UNITED STATES PATENT AND TRADEMARK OFFICE

Office Action Summary

10/662,702

SCHARF ET AL.

FIGURE 1***Claim Rejections - 35 USC § 103***

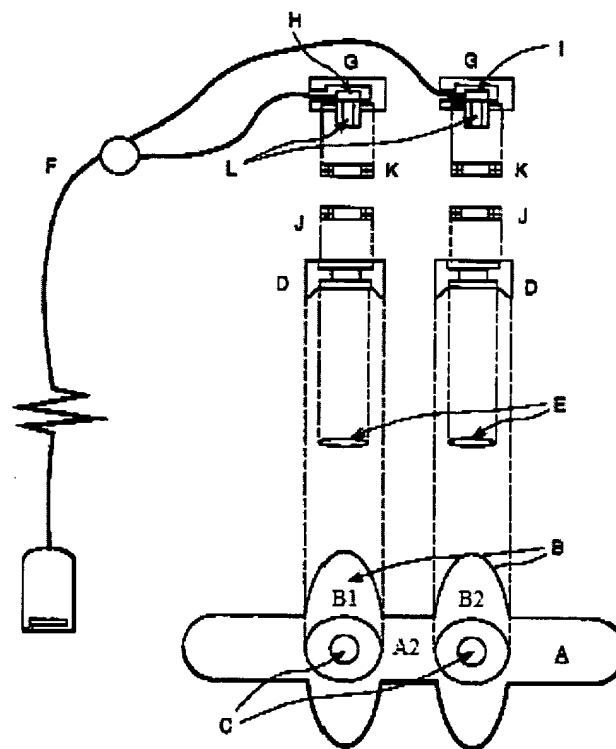
Parker'868 discloses a pulse oximeter system comprising: a transmission type sensor having a light emitting diode H and a detector I, each having their own housing G (col. 2, lines 45-54), wherein the light emitting diode and the detector are capable of being positioned with a patient's chin juxtaposed in between the diode and detector; securing means comprising an adhesive layer on the detector housing and

on the light emitting diode housing (col. 3, lines 27-35). Figure 1 of Parker'868, shown below, discloses the system wherein the securing means comprises two separate, adjustable straps, B1 and B2, wherein the first strap B1 is in physical communication with the detector housing when the detector housing is placed in aperture C, and the second strap B2 is in physical communication with the light emitting housing when the light emitting housing is placed in aperture C, and straps B1 and B2 are integrally formed by strap A2, to form apparatus A.
